**Re: McKinley Bicycle Center/ PHASE 1 Renovations
3333 Truman St. NE
30-Day Temporary Certificate of Occupancy
Transportation Development Final Inspection
Architect's Stamp dated 11-04-21 (G17-D091)
Certification dated 06-27-24**

Reference: TCL Comments (G17-D091)
McKinley Bicycle Center – Phase I Renovations

**McKINLEY BICYCLE CENTER
PHASE 1 RENOVATIONS**
3333 TRUMAN ST NE
ALBUQUERQUE, NM 87110

A1 TRANSPORTATION CIRCULATION LAYOUT
1" = 20'-0"

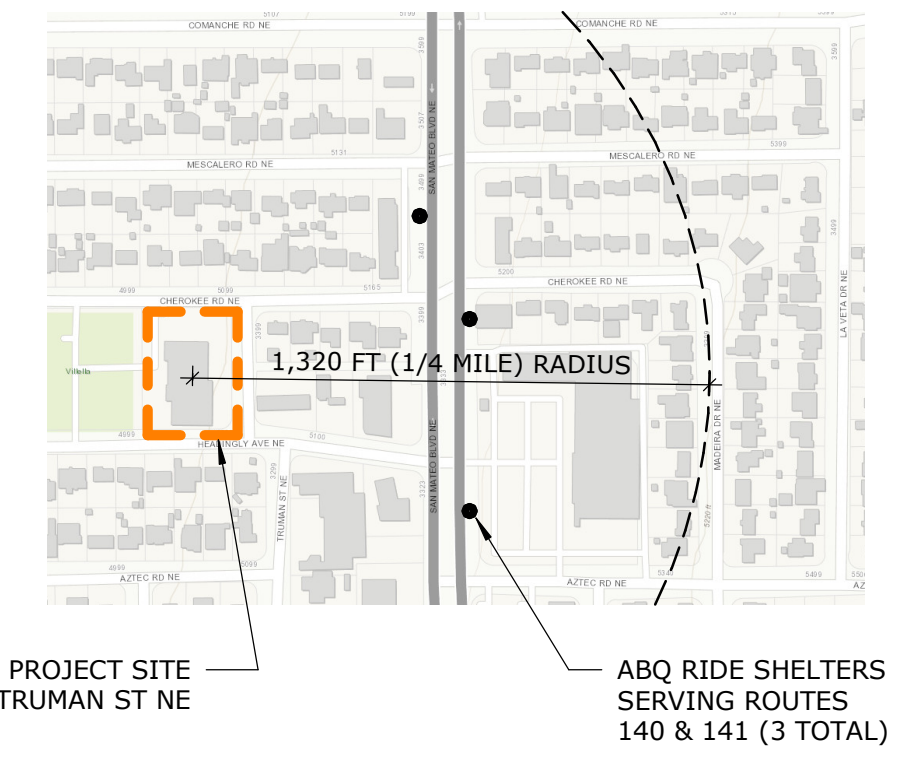
On February 3rd and 4th, Greer Stafford received comments for a revised Traffic Circulation Layout. Below are the items noted by the COA Planning Department's re-review of our submittal for Traffic Circulation Layout approval and in *italics* our response to how the deficiencies were addressed in this resubmittal.

- 1) Sidewalk keyed note: *Keyed note 32 13 13.SW description has been revised to reference COA standard detail 2430 as requested.*
- 2) Apron keyed note: *Keyed note 32 13 13.SA description has been revised to reference COA standard detail 2425 as requested.*
- 3) Detectable warning devices at aprons: *Detectable devices at aprons have been deleted as requested.*
- 4) Detectable warning devices at corner curb ramps: Detectable devices at corner curb ramps have been deleted and will be installed per City and ADA standards as part of the deferred phase 2 improvements identified in the previously provided infrastructure list.

A3 HANDICAP ACCESS RAMPS
1/2" = 1'-0"

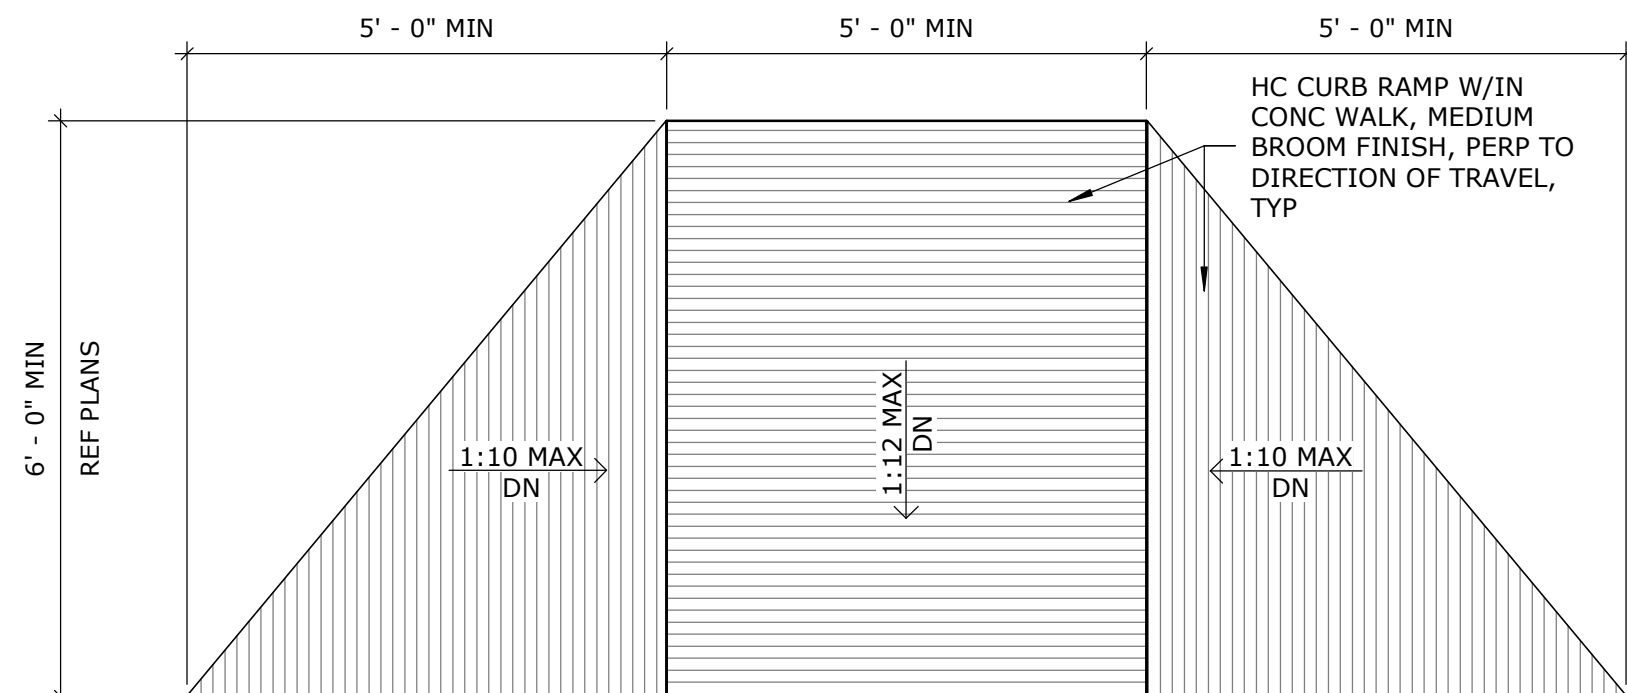
- The ADA pathway from the public sidewalk to the building entrance must be accessible. Please remove the fence from this area to ensure compliance.
